Docket Number:	14-AAER-02
Project Title:	Computer, Computer Monitors, and Electronic Displays
TN #:	205340
Document Title:	Chris Hankin, Information Technology Industry Council Comments: June Deep Dive Mtg, ITI/Technet Displays Presentation -- Dell Corp
Description:	N/A
Filer:	System
Organization:	Chris Hankin/Information Technology Industry Council
Submitter Role:	Public
Submission Date:	7/14/2015 5:22:12 AM
Docketed Date:	7/14/2015

June Deep Dive Mtg, ITI/TechNet Displays Presentation -- Dell Corp

Displays Cost Effectiveness/ Technical

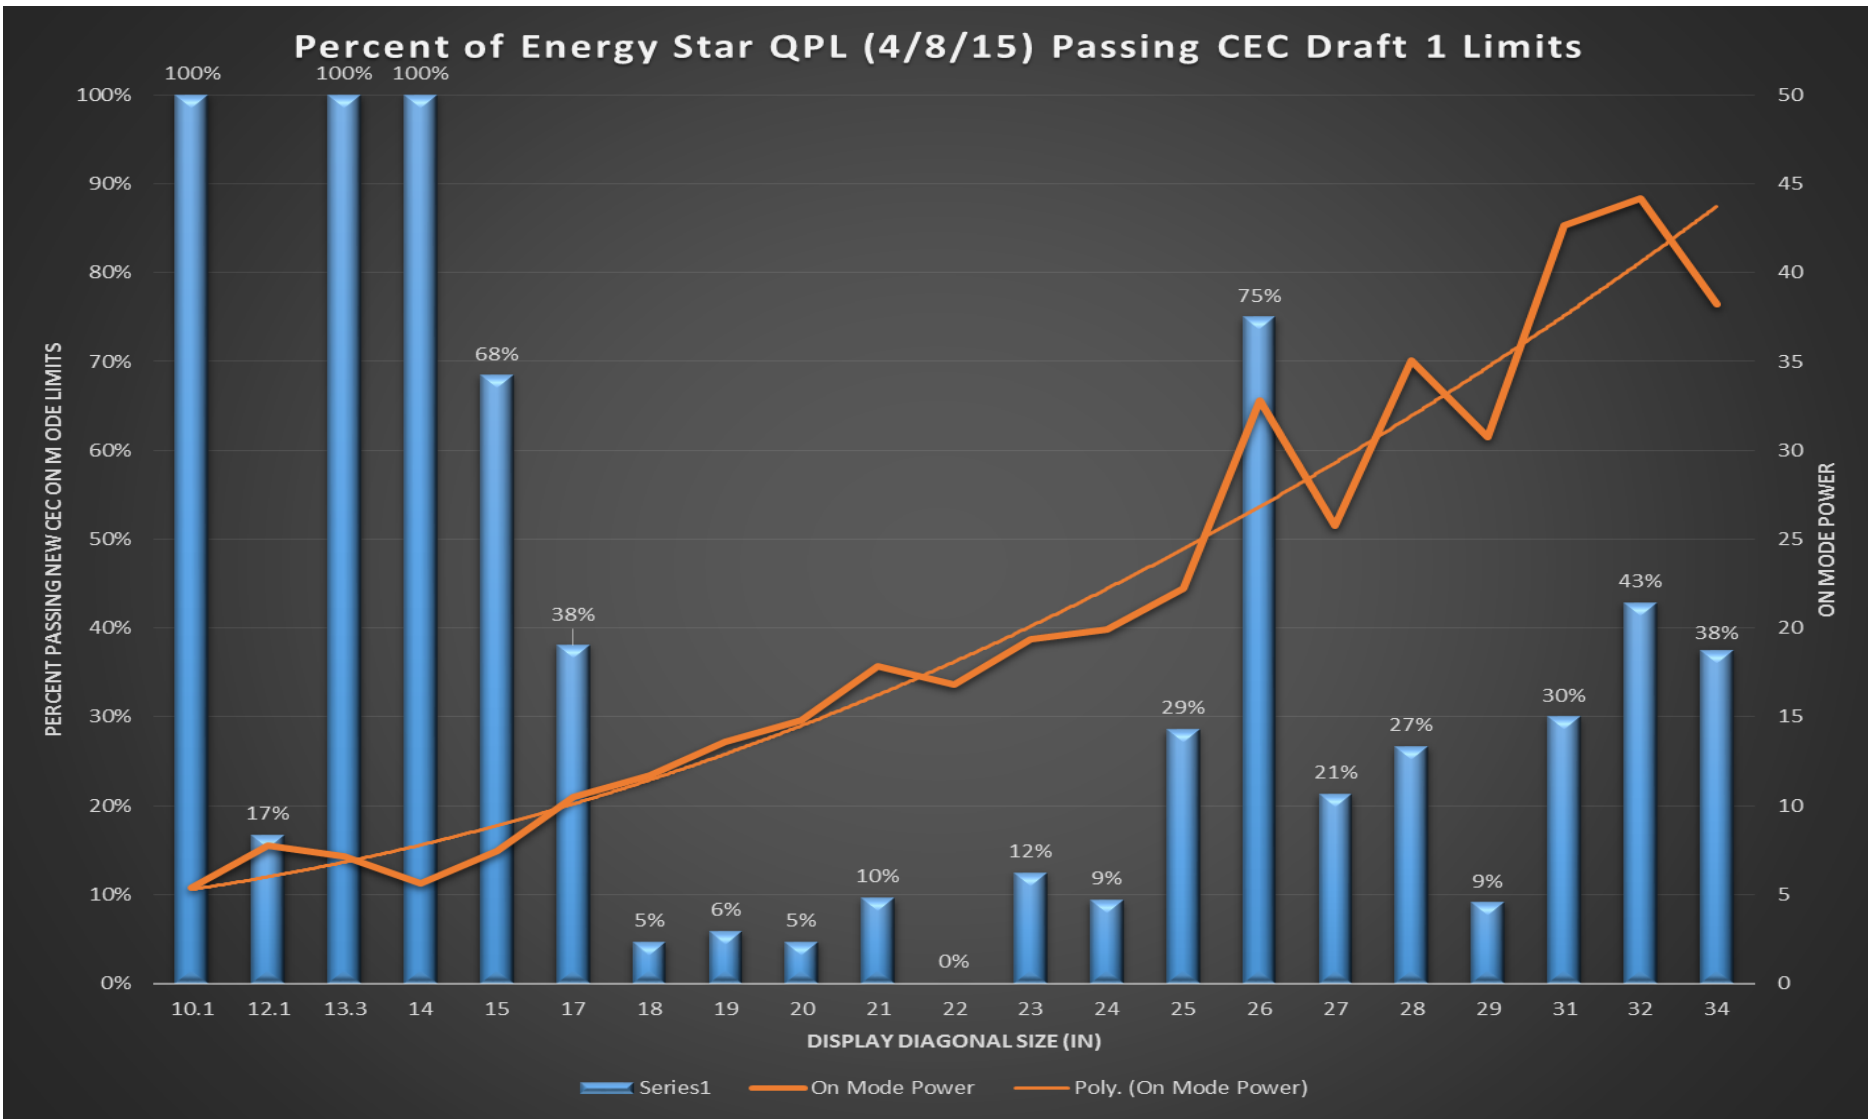
- Key Customer requirements are completely un accounted for in CEC limits or in many of the IOU comparisons
 - Color Gamut large driver of Power consumption but not in analysis
 - CEC regulation will eliminated high color gamut displays from the California market
 - Video editing among industries where color Gamut is essential
 - Viewing Angle
 - Wider Viewing Angles require brighter backlights to hit same front of screen brightness
 - Optional Features (Later in presentation)
- CEC analysis of USB powered display incorrect for comparison to AC mains powered displays
- Requirement of best available technology problematic for volume production
 - May be manufacturer selective
 - Cost Premium will grow if excessive demand

- Energy Star QPL 4-8-15 vs adjusted CEC On mode limits

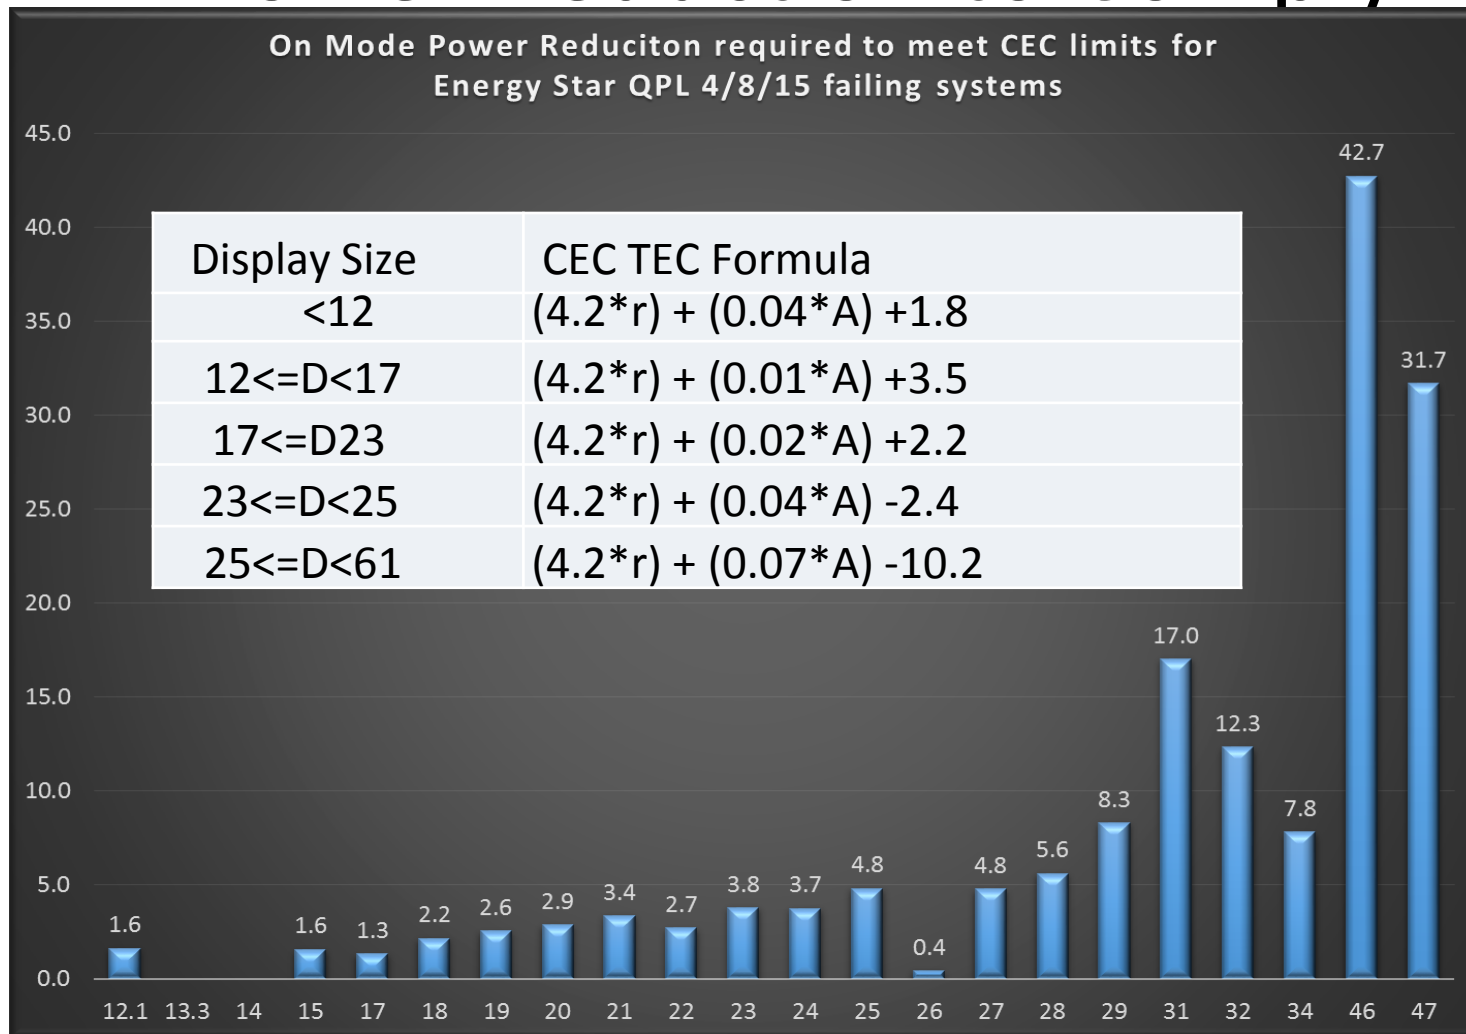
- 17-23 in displays much more severely impacted by adjusted CEC proposed limits
 - Same technologies and suppliers used across most size ranges

- CEC analysis states only about 14 percent of the current models meet the staff's proposed standards. However, monitors would only need to reduce their power consumption by 3 to 5 watts to comply
